SUPPLEMENTAL BID BULLETIN NR. DND-AFP/PNBSLP-18-07-001

PN Base Support and Logistics Project

This Supplemental Bid Bulletin is issued to inform prospective bidders of the clarifications and amendments in the Bidding Documents for the PN Base Support and Logistics Project (Phase I) Construction of Various Facilities (Line Item 1-10) at Naval Base Rafael Ramos, Brgy Looc, Lapu-Lapu City, Cebu:

Proposed Stockyard and Staging Area

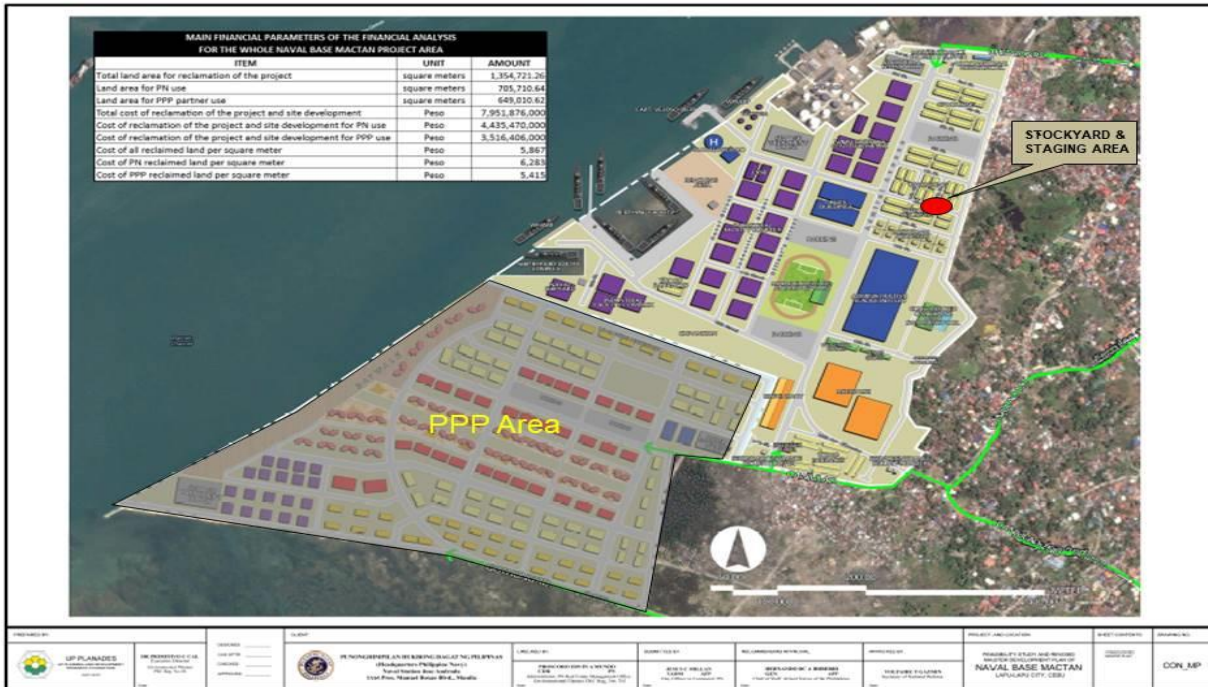
17	Please provide a location plan reflecting the staging area and stockyard; and	Location Plan reflecting the Staging Area and Stockyard is attached hereto.
	18	Where is the tapping point for the Proposed Construction of Shore Power System. Please indicate in the location.	Tapping point will be at the nearest existing shore power sub-station (refer to sheet no. w1 15-17 of the plan).
MARRA BUILDERS, INC.	1	As per the Pre-bid Conference, when will you provide us the overall minimum list of equipment required for this project?	Following are the list of minimum equipment that must be owned or leased:
